UNITED STATES PATENT AND TRADEMARK OFFICE

Office Action Summary	Application No. 10/537,380	Applicant(s) BAECKER ET AL.	
	Examiner Brent T. O'Hern	Art Unit 1772

DETAILED ACTION

FIG. 2

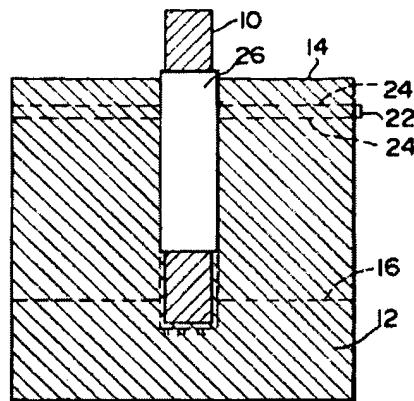
Regarding claim 21, Baecker ('921) teaches a field liner (*col. 4, l. 44 and FIG-2, #26*) for protecting a timber pole against subsoil decay (*col. 4, l. 44 and col. 2, ll. 54-56*), which includes a sheet element that forms an elongate sleeve of which one end is at least partially sealed (*col. 2, ll. 47-48*), the sheet element being in the form of a laminate structure (*col. 3, l. 44*) including a first layer of material (*col. 2, ll. 46-53*), and a second layer of material (*col. 2, ll. 57-59*), with the first layer of material being a flexible (*col. 2, ll. 46-53*), liquid impermeable, non-biodegradable synthetic plastics film material (*col. 2, ll. 57-59*) that contains a dry film biocide therein (*col. 2, l. 61*) and defining the inner surface of the sleeve and the second layer of material being a flexible (*col. 2, ll. 46-53*), liquid impermeable (*col. 2, l. 58*), non-biodegradable (*col. 2, ll. 58-59*) synthetic plastics

film material (*col. 2, ll. 57-59*) that is tear resistant (*col. 5, ll. 25-26*), and defining the outer surface of the sleeve (*col. 2, ll. 57-59*), however, fails to expressly disclose in which the second layer of material is provided with a strip of an adhesive substance externally thereon.

FIG. 4

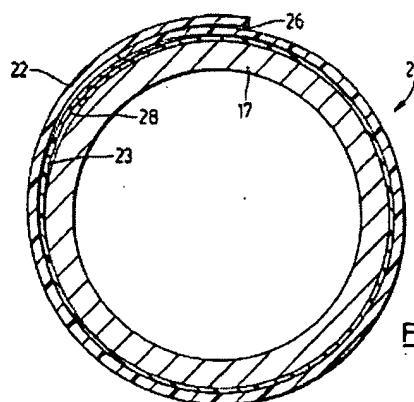
However, Steele ('428) teaches in which the material is provided with a strip of an adhesive substance externally thereon (*FIGs 3-4, #26 and col. 3, ll. 25-35*) for the purpose of holding down the liner and providing adhesion between the layers (*col. 3, ll. 34-35 and col. 4, ll. 31-36*).

However, Steele ('428) teaches wherein the adhesive substance is covered by a peel-off strip (*FIGs-3-4, #26, col. 3, ll. 25-35 and col. 4, ll. 47-50*) for the purpose of applying additional materials to the underlying layers (*col. 4, ll. 47-50*).
